Proposal Request

Architect's Project Number: 993A
Proposal Request Number: 088R
Proposal Request Date: 10.14.2024

Revisions to Dean's Office Area

Revised drawings in PR 088 updated per request for an additional secure door on level 4 in Dean's office area. PR 088R revised sheets are marked in red and include updated revision clouds.

1 L4 - 1/8" DIMENSION PLAN - AREA A
1/8" = 1'-0"

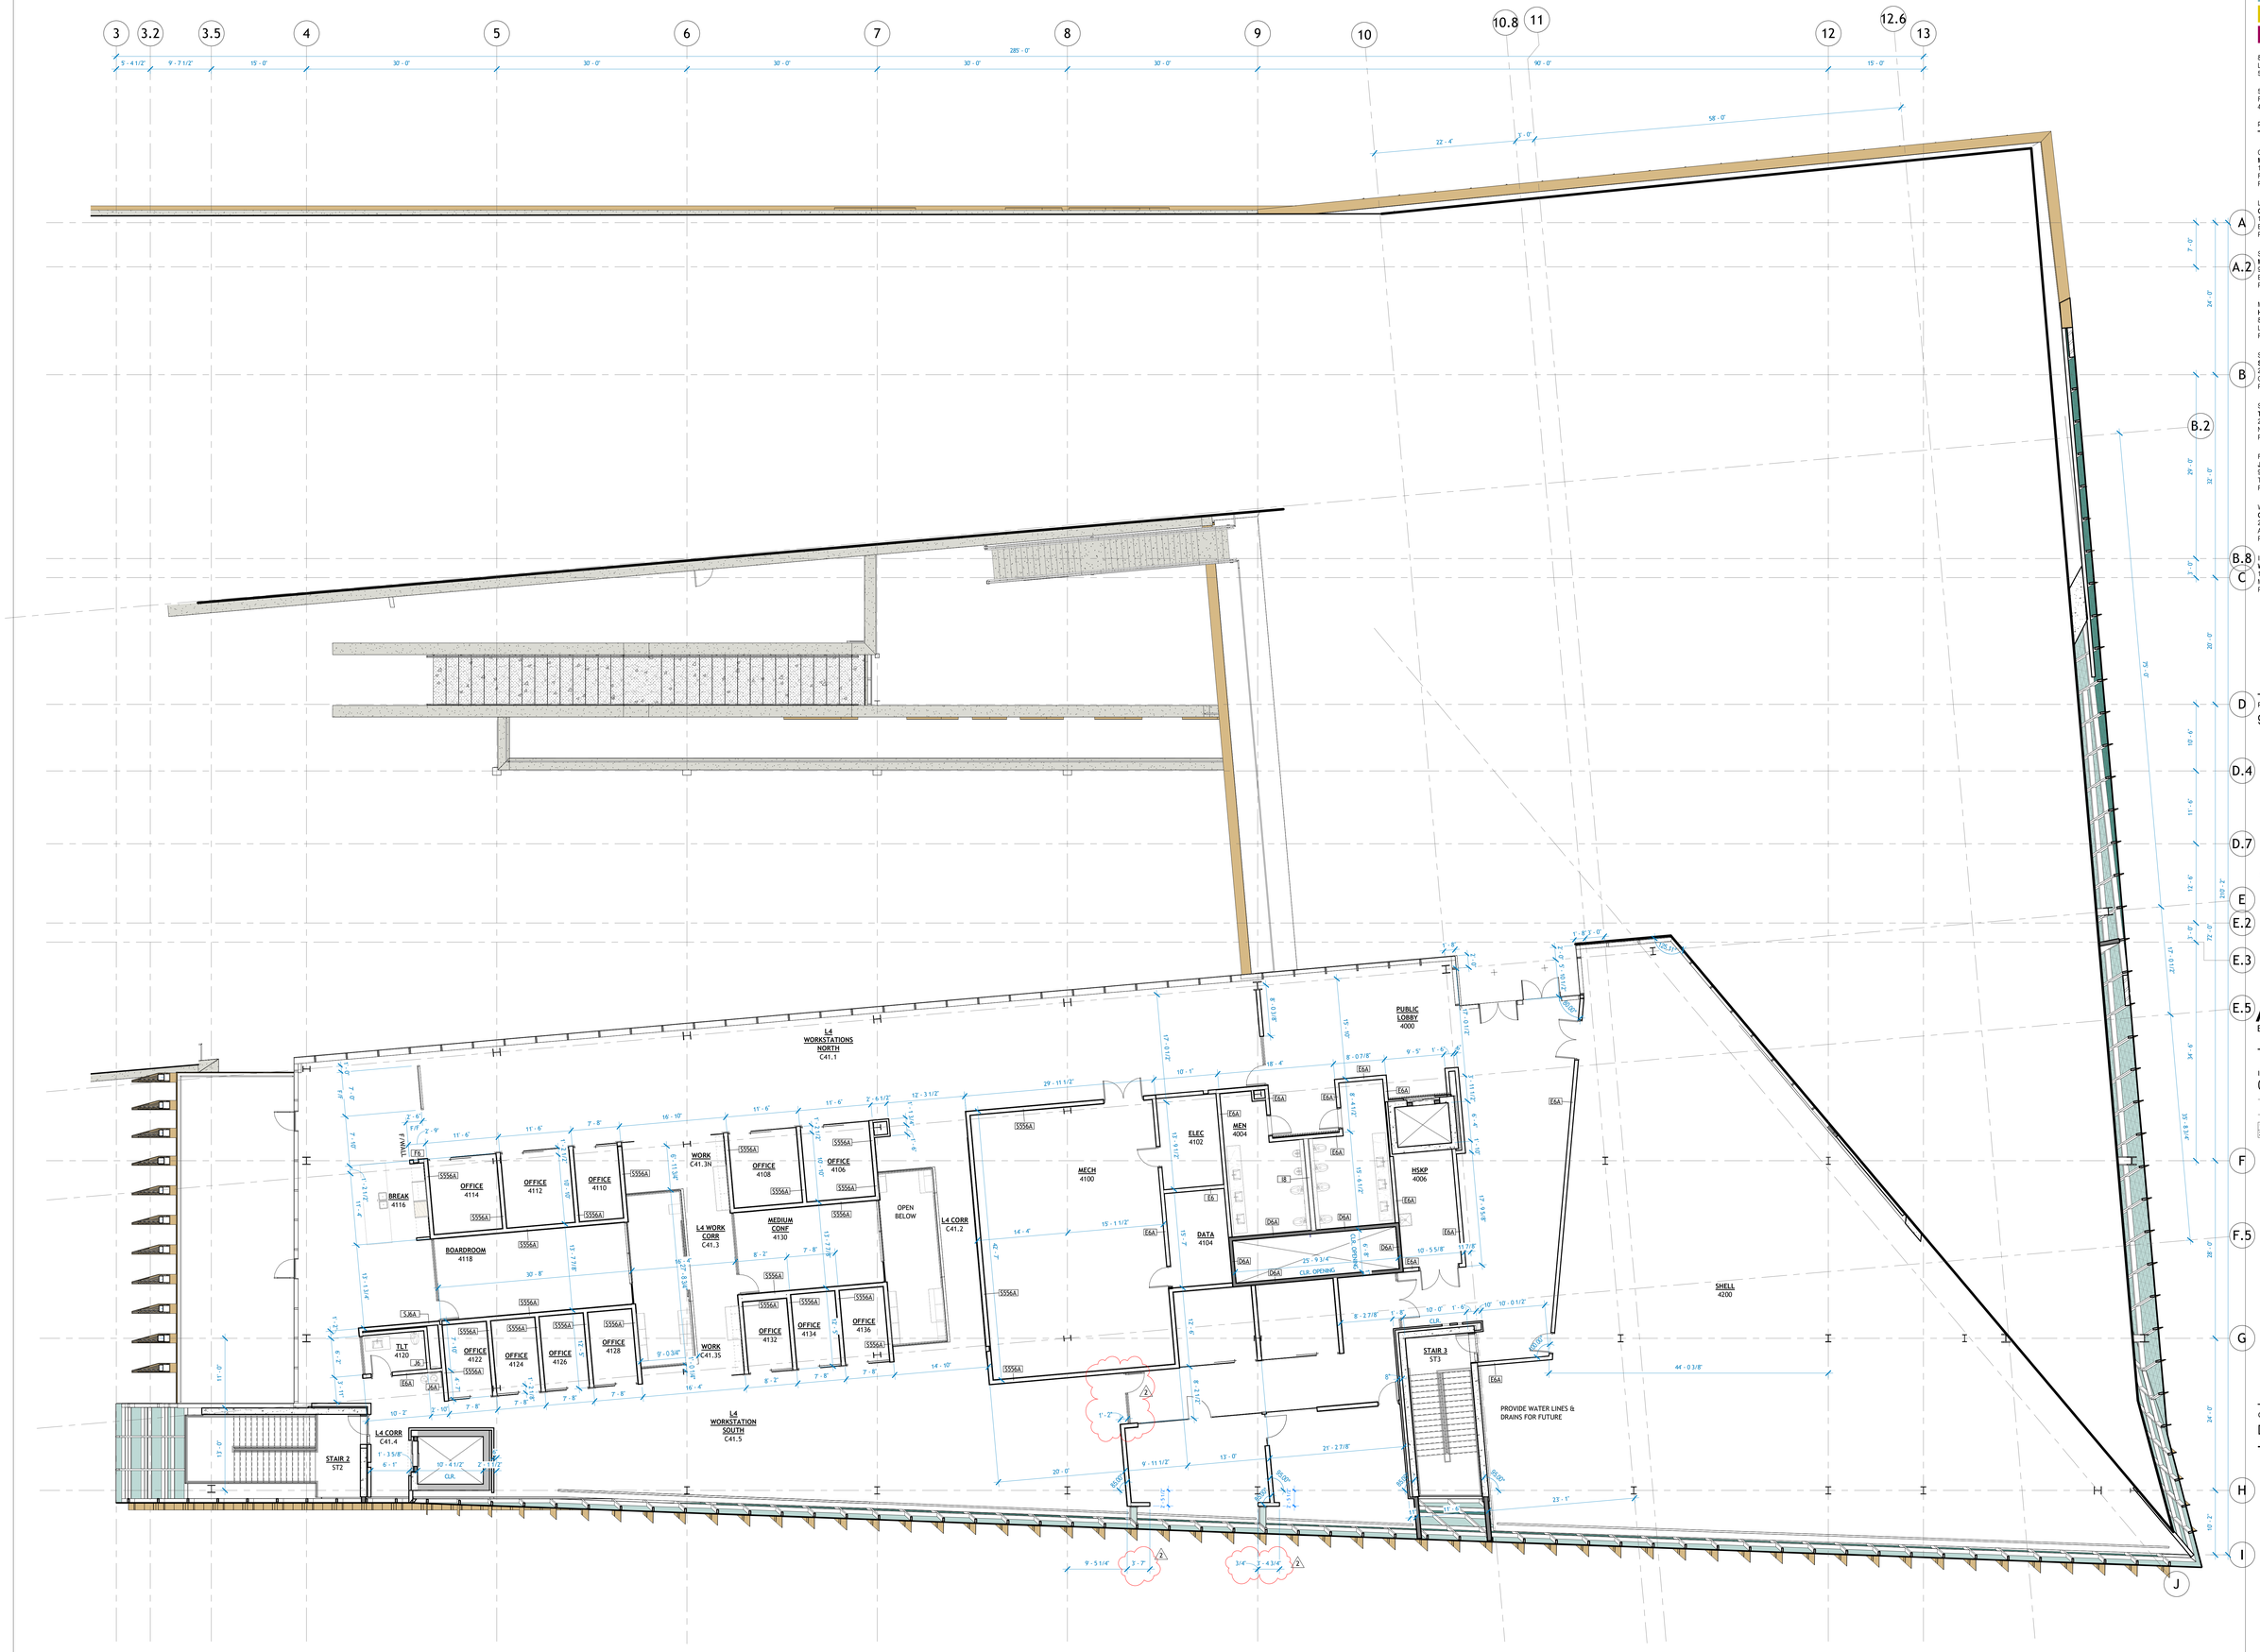
- **b)** Refer to Revised Sheet **A104AD,** Detail **1**, with original issue date 02.24.2023 and revised date 10.07.2024.
     - Add dimension to new storefront wall

- Revise/ Clarify dimensions at exterior closure walls
   - **c)** Refer to Revised Sheet **A204,** Detail **1**, with original issue date 02.24.2023 and revised date 10.07.2024.

1 LEVEL 4 - CEILING PLAN
1/8" = 1'-0"

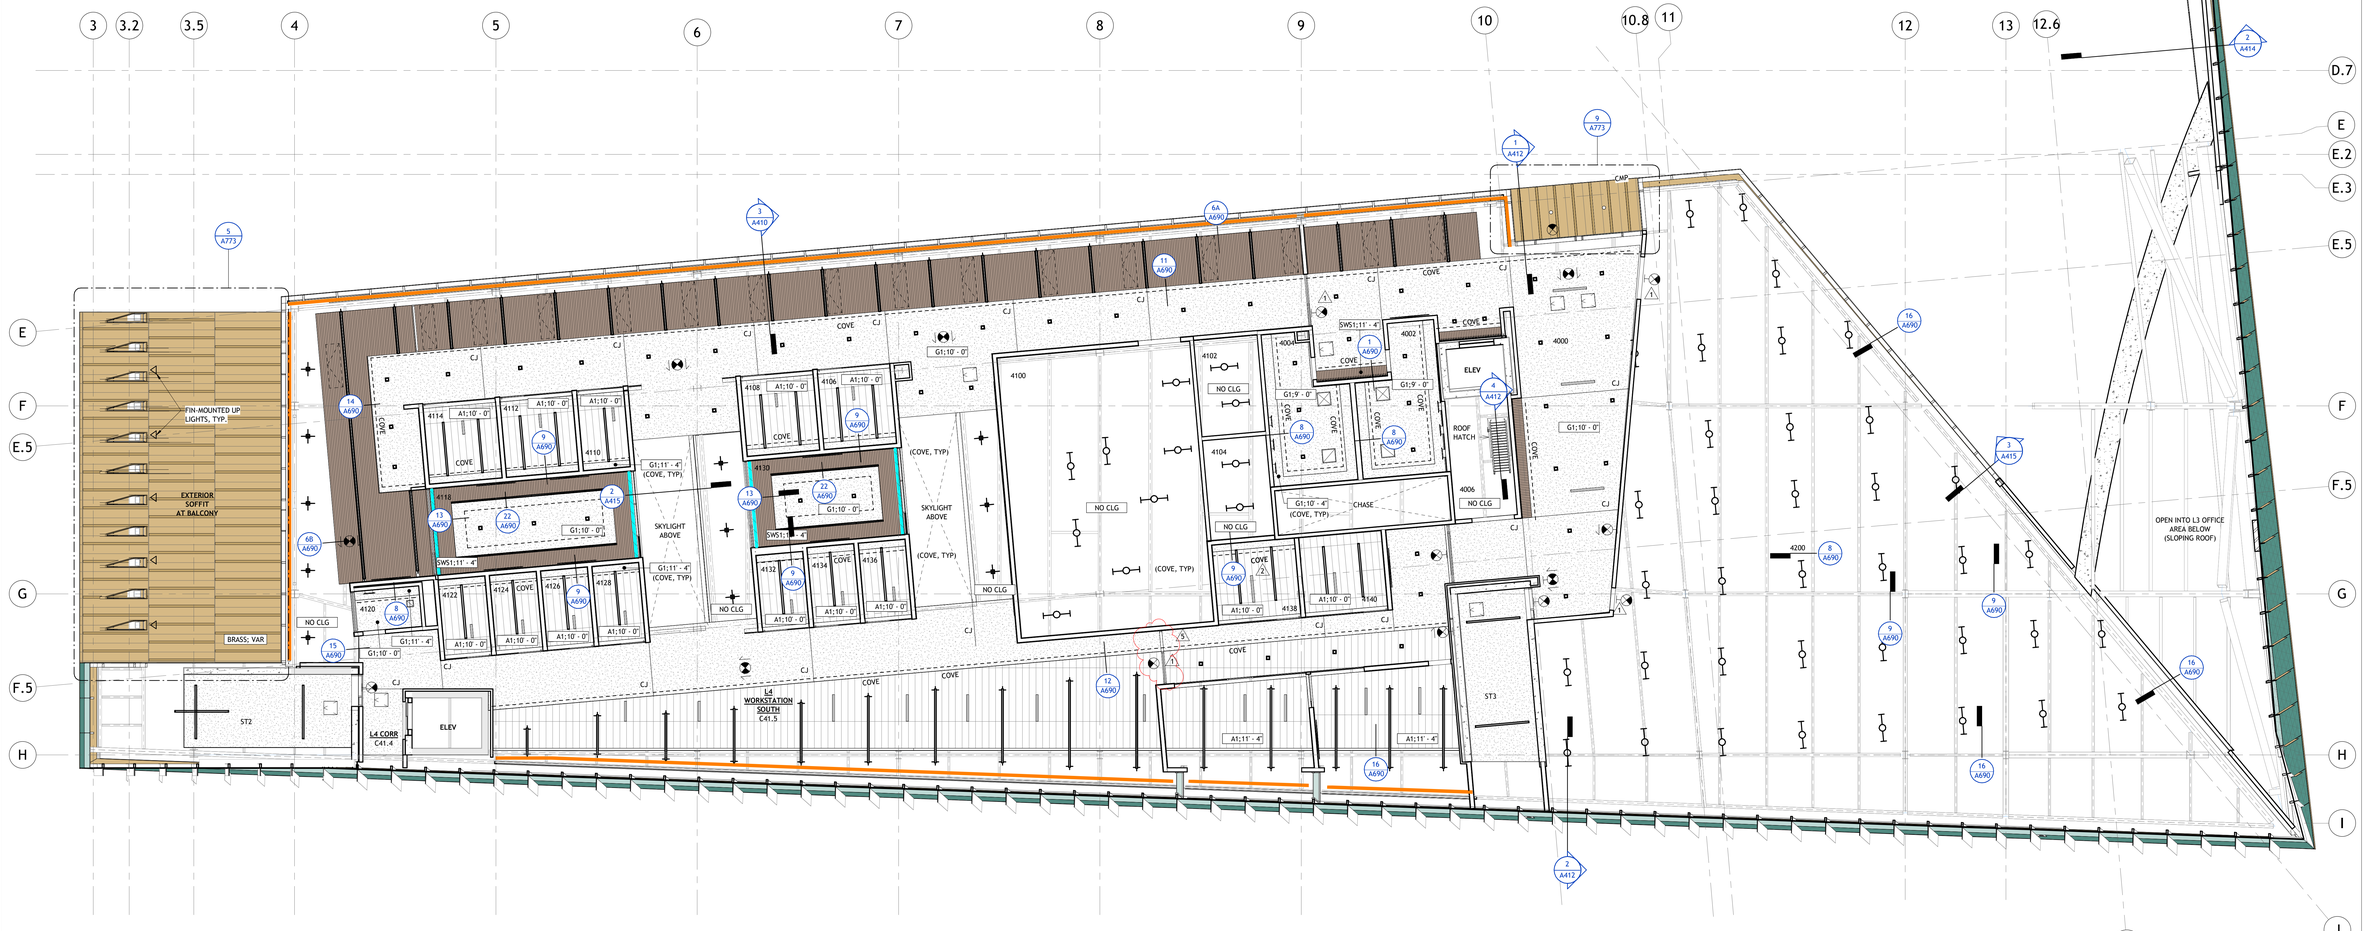
- Add new storefront wall to RCP, with new exit sign
   - **d)** Refer to Revised Sheet **A710, CURTAINWALL/ STOREFRONT ASSEMBLY SCHEDULE**, with original issue date 02.24.2023 and revised date 10.07.2024.

S4.06 C41.6 DEANS SECURITY DOOR

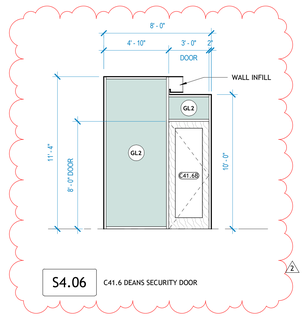
- Add new storefront door C41.6B
   - **e)** Refer to Revised Sheet **A752**, with original issue date 02.24.2023 and revised date 10.07.2024.
     - Add new storefront elevation S4.06

1 **L4 - FINISH PLAN**
1/8" = 1'-0"

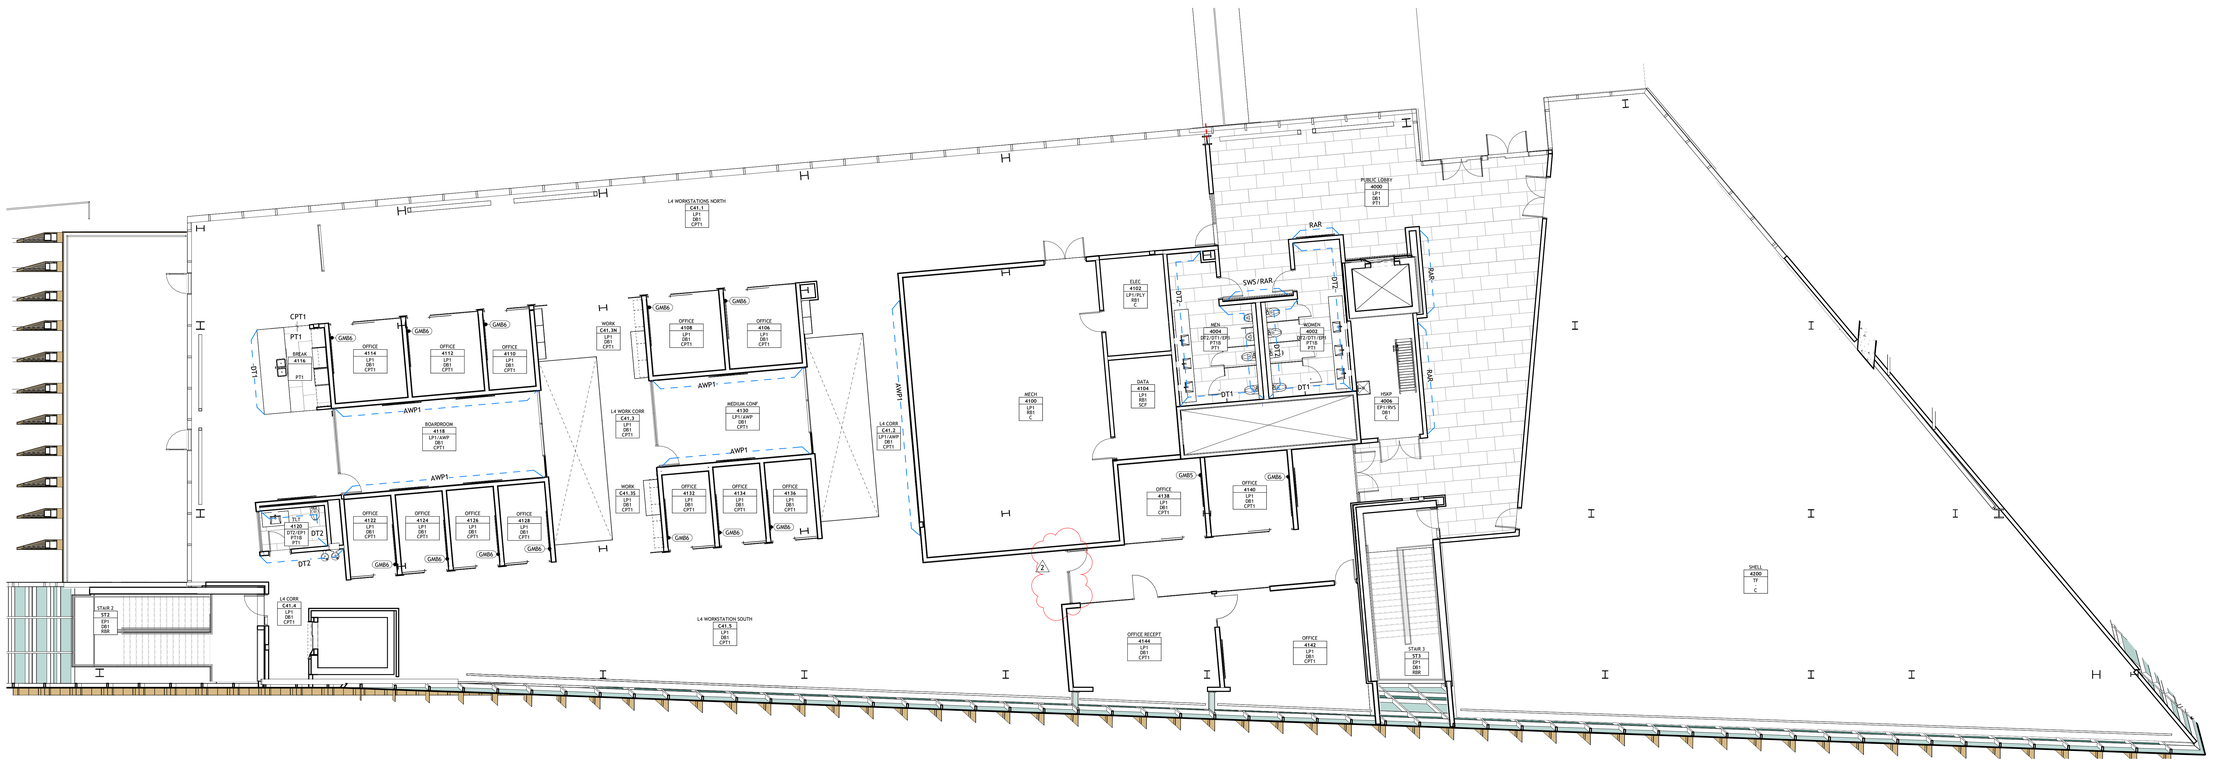
- **f)** Refer to Revised Sheet **A804**, with original issue date 02.24.2023 and revised date 10.07.2024.
     - Add new storefront wall to Finish Plan

1 L4 - LIFE SAFETY PLAN
1/16" = 1'-0"

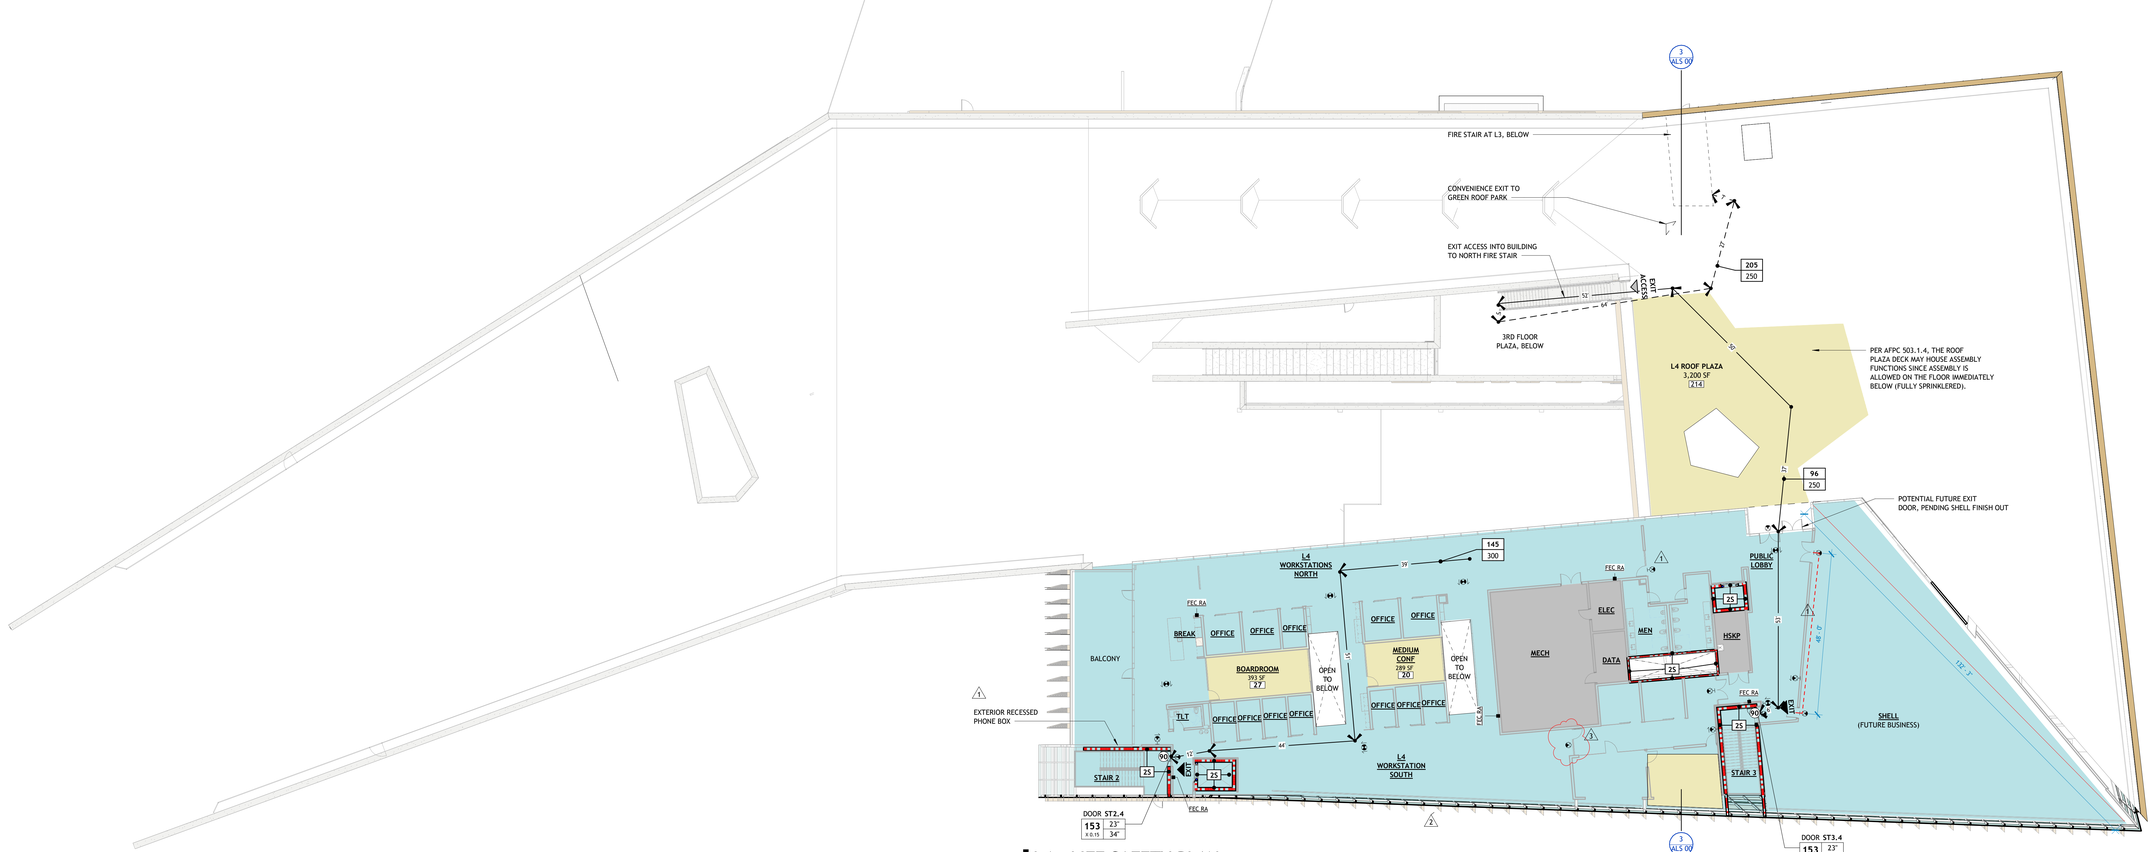
- **g)** Refer to Revised Sheet **ALS04**, with original issue date 02.24.2023 and revised date 10.07.2024.
     - Add new storefront wall to Life Safety plan, with new exit sign
